Far-forward/far-backward review summary

Electron-Ion Collider

EIC Preliminary Design & Safety Review of the EIC Auxiliary Far-Forward/Far-Backward Detectors (Feb 12, 2024)

For EMCAL:
PbWO₄ vs LYSO

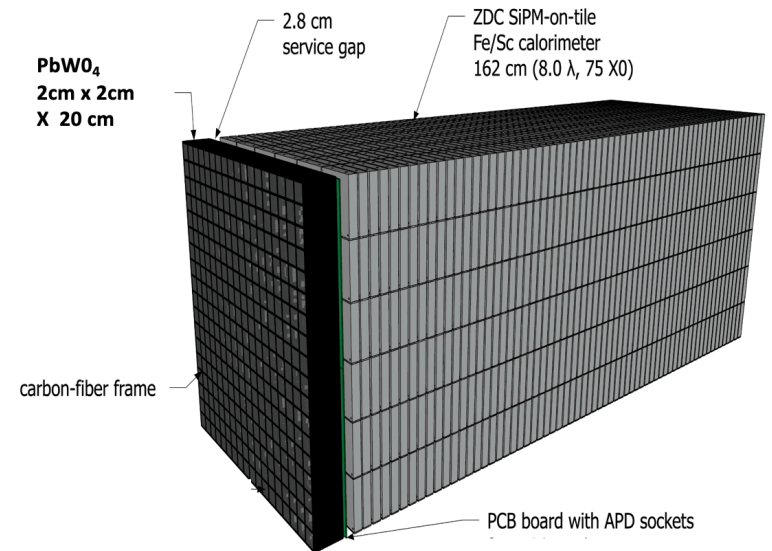
1. Are the technical performance requirements appropriately defined and complete for this stage of the project? **YES, for most components.**
 - The requirements are generally well done and credible for all systems
 - Concerning the hadron calorimeter good decisions have been taken. **The decision on the crystal type should be taken as soon as possible** as it affects the readout.
 - The DAQ is very challenging in general

Luminosity system

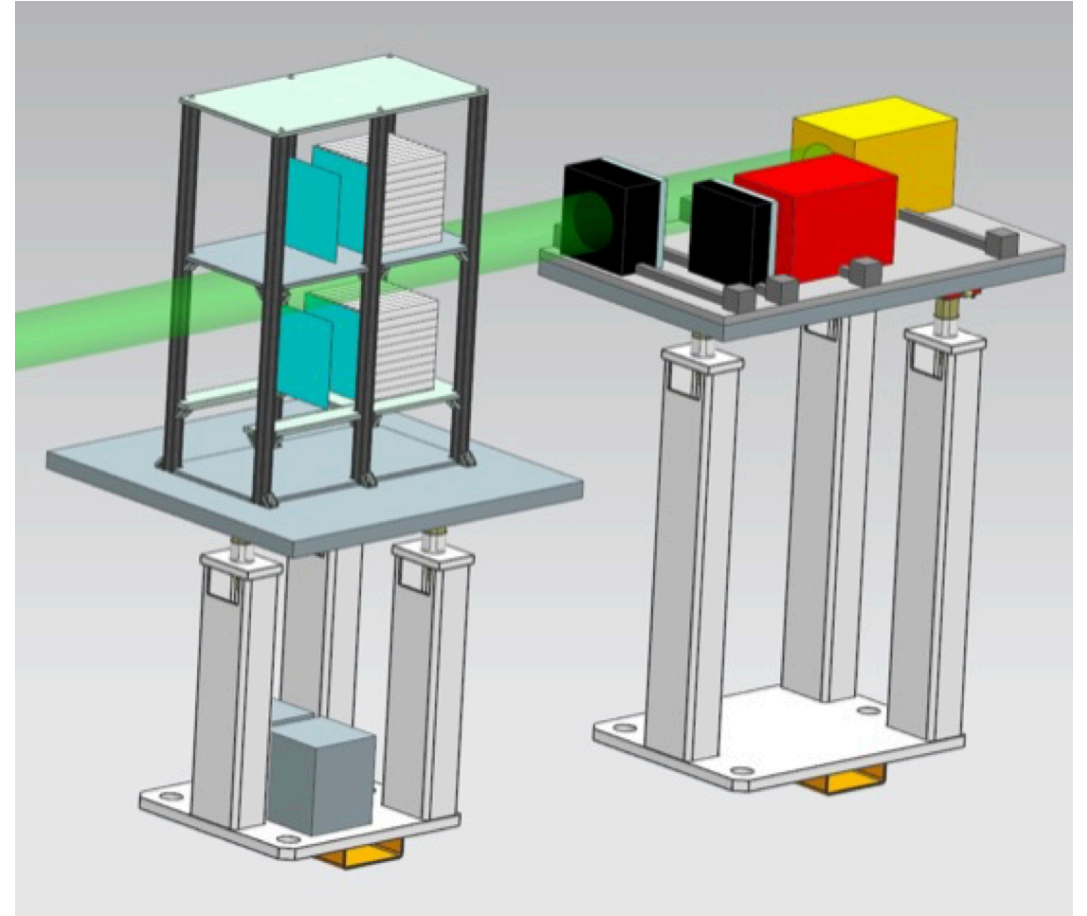
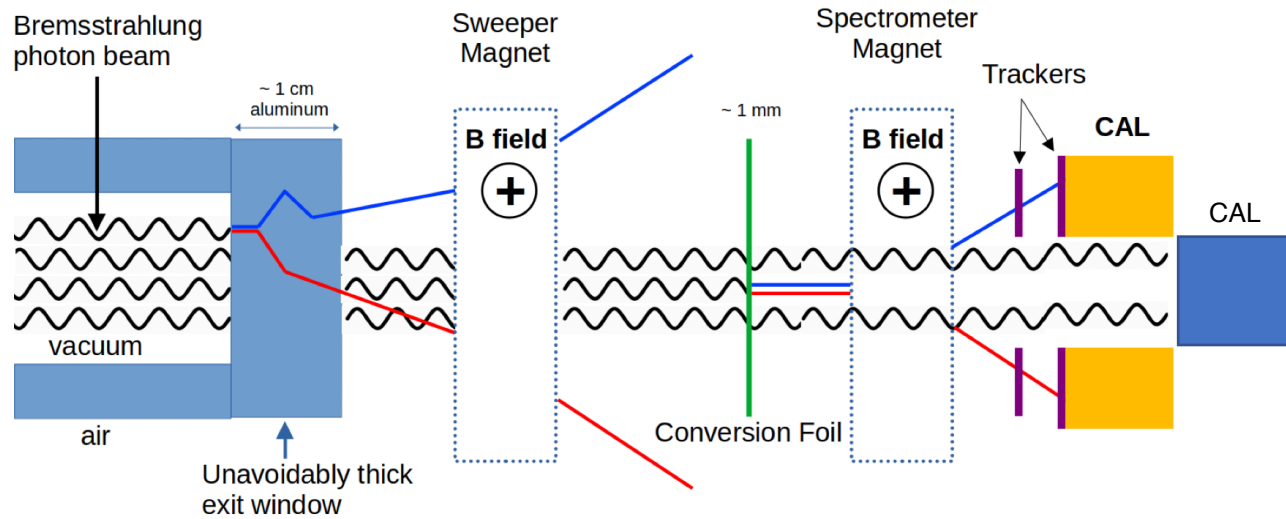
More elaboration and explanation on **how to achieve 1% luminosity** precision with the calorimeter is needed

The justification for requirements of the **direct photon calorimeter at high luminosity** is not convincing

B0-installation

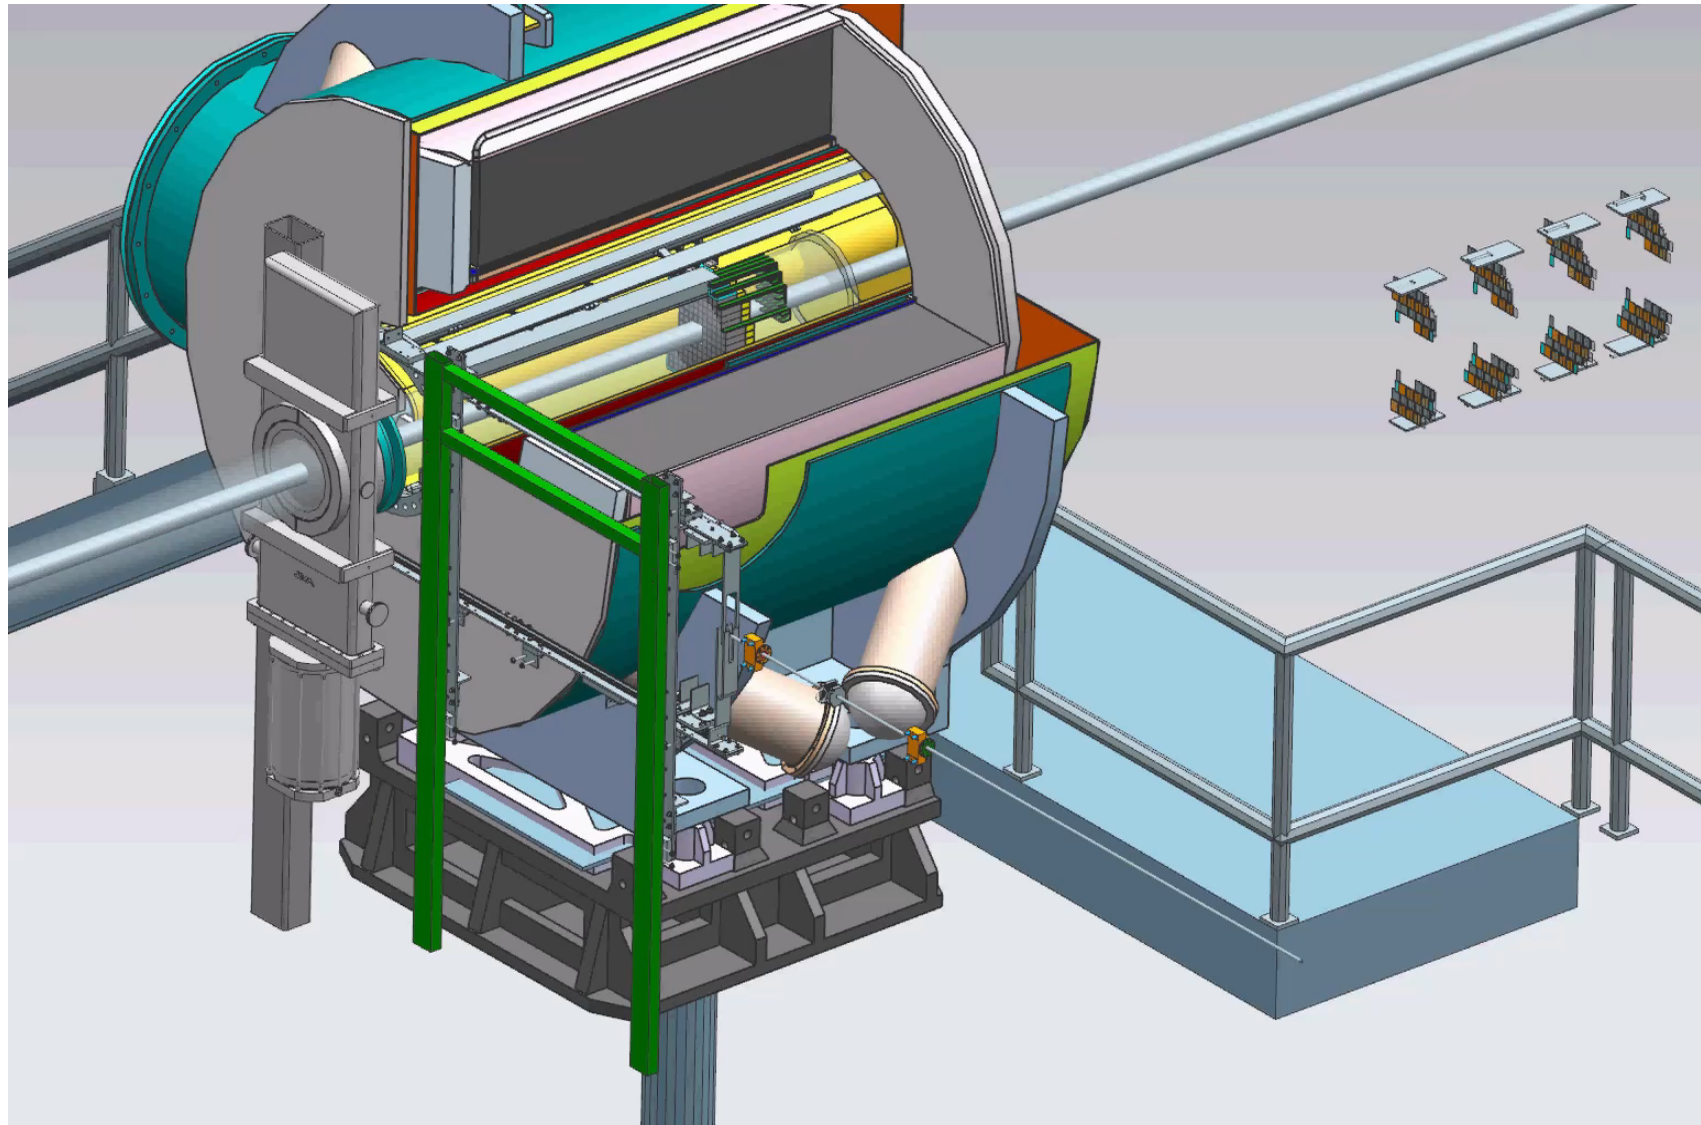
The **insertion mechanism of the tracker into the B0** appear extremely challenging and need major development work

- Develop plans for **insertion** of tracker and calorimeter readout into B0 magnet, including decision whether the device should be **serviceable** as soon as possible but not later than the next review
